**CITY OF KIRKLAND
DEPARTMENT OF PUBLIC WORKS**

**108th Ave NE Sewer and Water Replacement
Project No. 48-19-PW
CIP NO. CSS-0052/CWA-0052**

ADDENDUM 1

SHEET:
 20A / 36
 SCALE:
 SEE GRAPHIC SCALE
 FILENAME:
 801802 - DESIGN

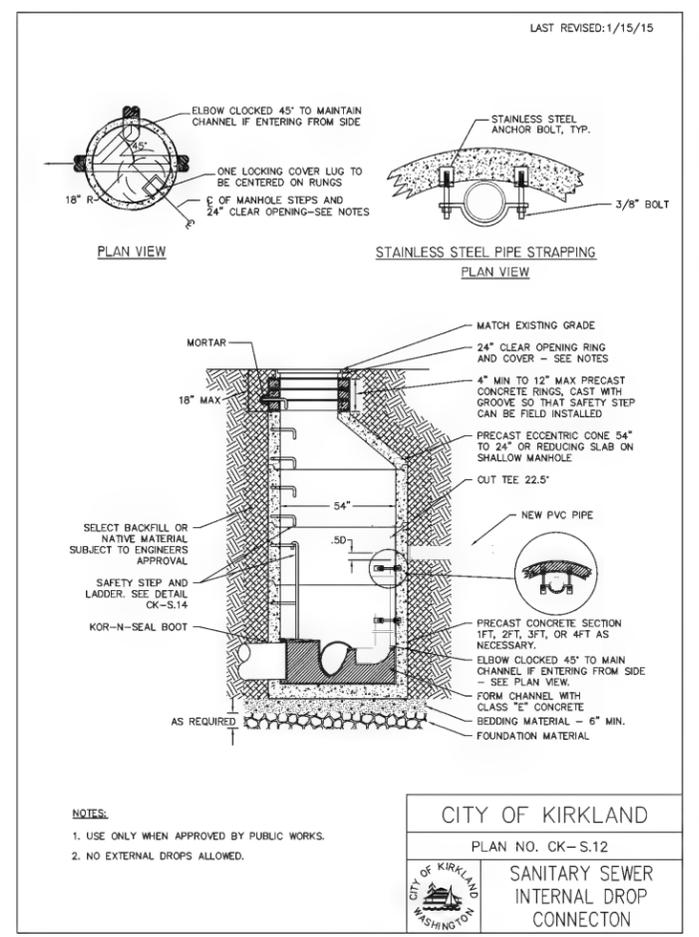
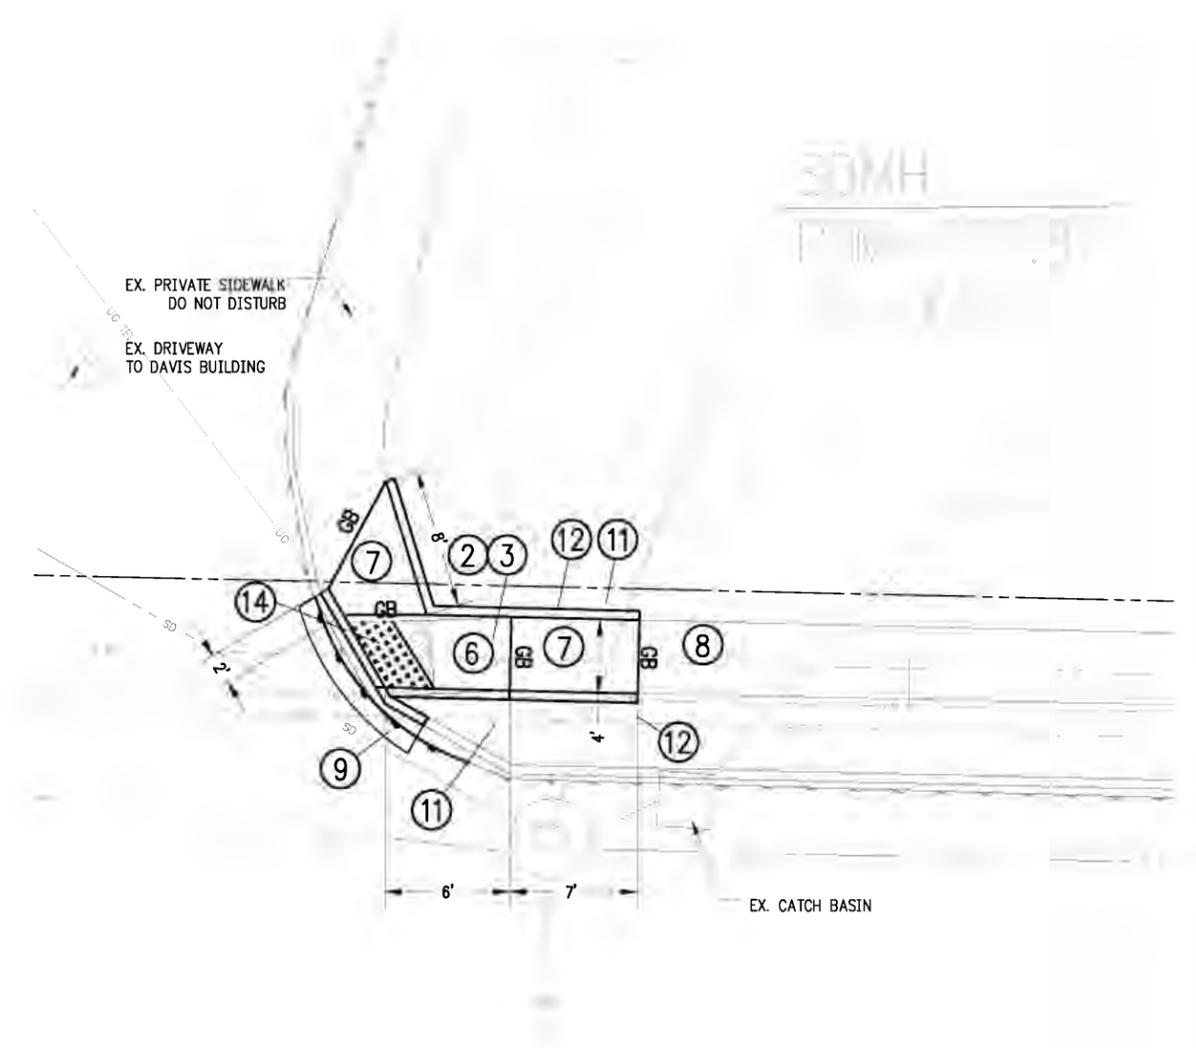
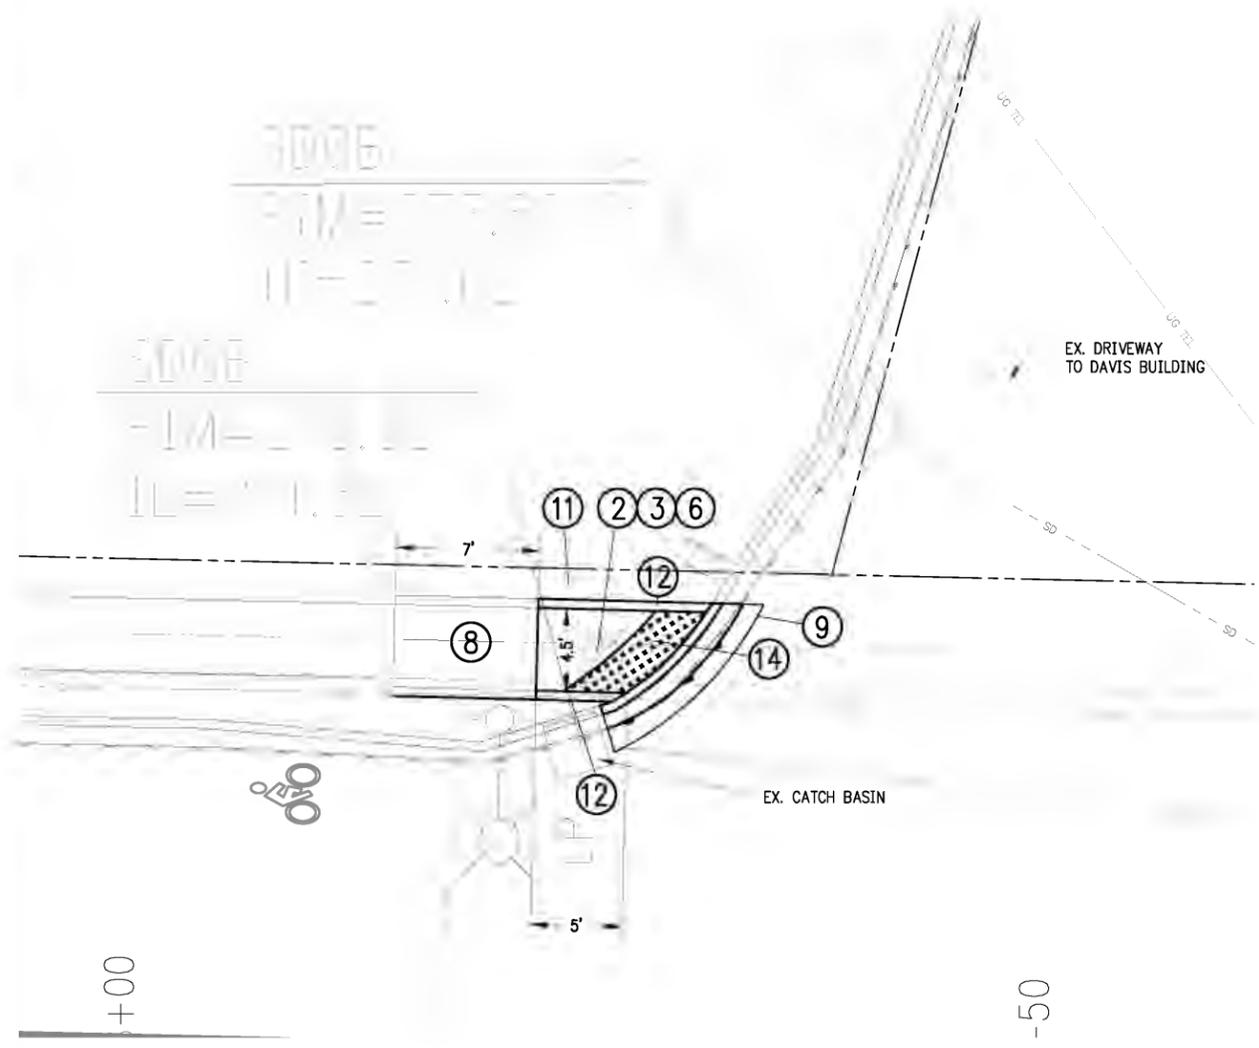
Add Sheets 20A and 20B as attached, to include additional curb ramp replacement details and City of Kirkland Pre-approved Plan CK-S.12.

LATERAL EARTH PRESSURES
FOR TEMPORARY BRACED SHORING

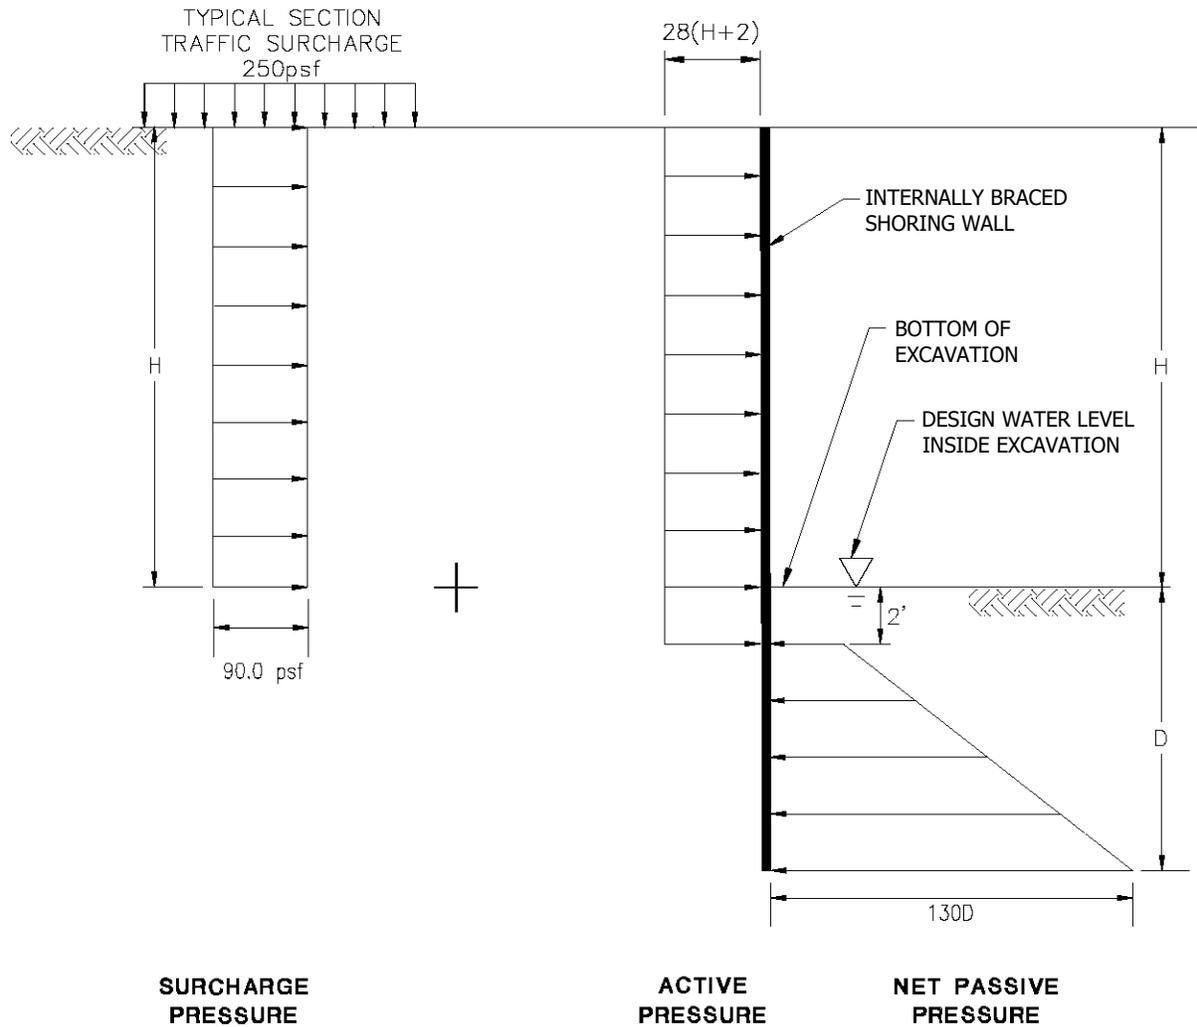
Where the soil conditions encountered require additional sidewall support other than trench boxes supplemented with steel sheets and struts, the shoring system implemented should be designed and constructed to support the lateral earth pressures exerted by the surrounding soil. The lateral earth pressures provided in Figure 1 can be used for design of braced temporary shoring and assumes the presence of very loose to loose fill materials over the full height of the shored excavation. This also assumes that the ground water level is at or lower than the base of the excavation, such that no hydrostatic pressure is able to build up behind the shoring or result in heave at the base of the excavation. A surcharge from lightly loaded vehicles is included and is equal to a surcharge of 2 feet of soil. Any additional surcharges from construction equipment, construction materials, or excavated soils should be included in the shoring design. We recommend that the contractor be required to submit a shoring/excavation plan for review prior to installation of the proposed system.
